HISTORIC AND DESIGN REVIEW COMMISSION

HDRC CASE NO: 2018-429
ADDRESS: 436 DEVINE ST
LEGAL DESCRIPTION: NCB 2958 BLK 2 LOT 44
ZONING: RM-4, H
CITY COUNCIL DIST.: 1
DISTRICT: Lavaca Historic District
APPLICANT: Jnie Barrera
OWNER: Jnie Barrera
TYPE OF WORK: Construction of a rear carport
APPLICATION RECEIVED: August 22, 2018
60-DAY REVIEW: October 21, 2018

REQUEST:

Site Plan

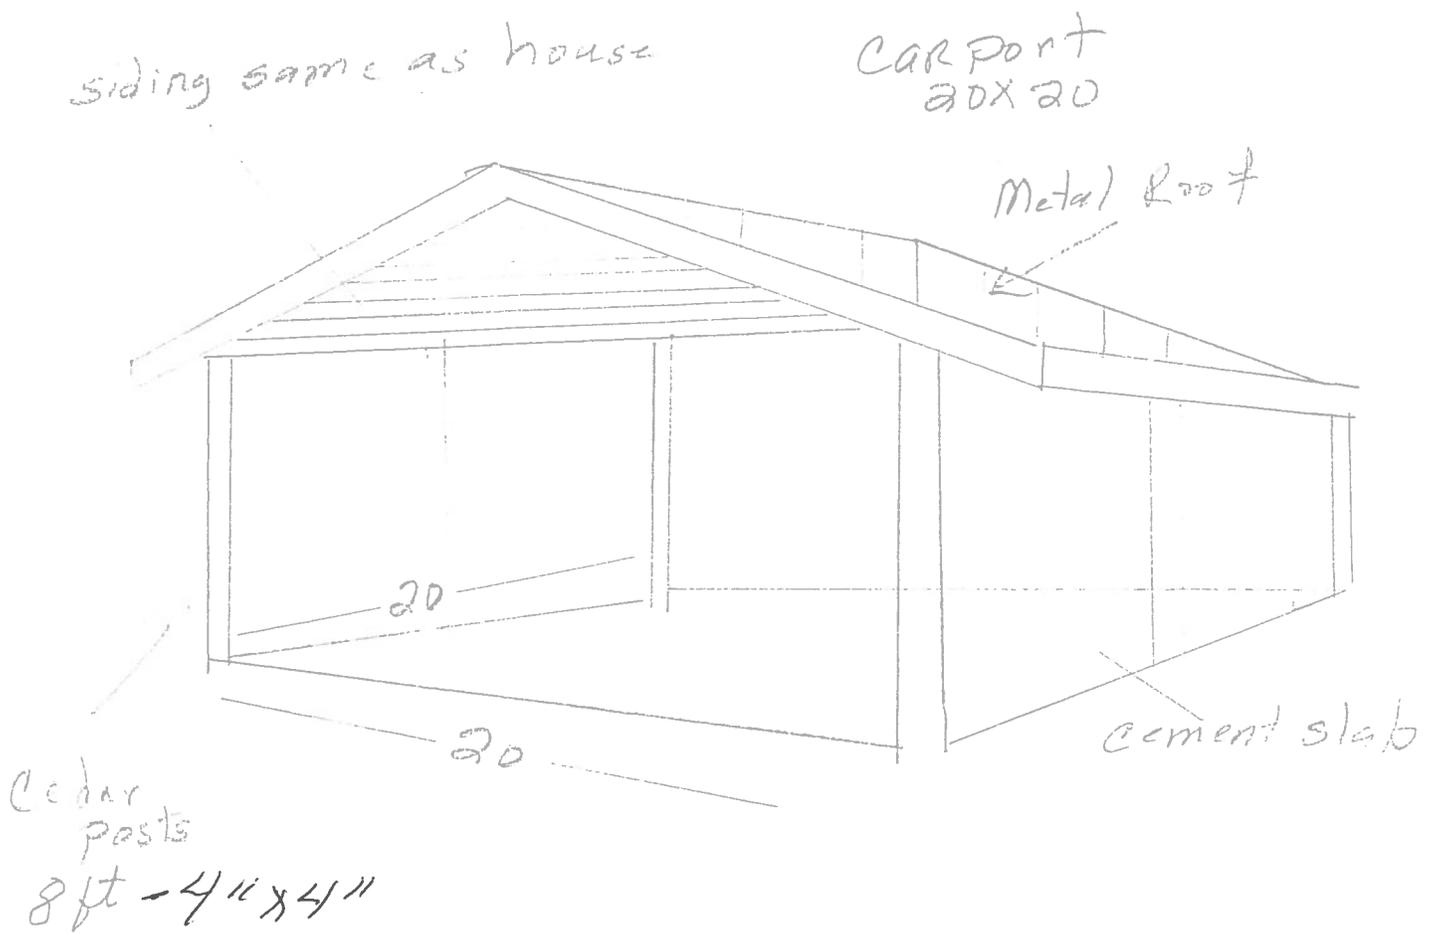
~~NEW CONCRETE PAVED DRIVEWAY~~
~~NEW DOUBLE SWING WOOD PICKET GATE~~

I am not adding driveway
EB
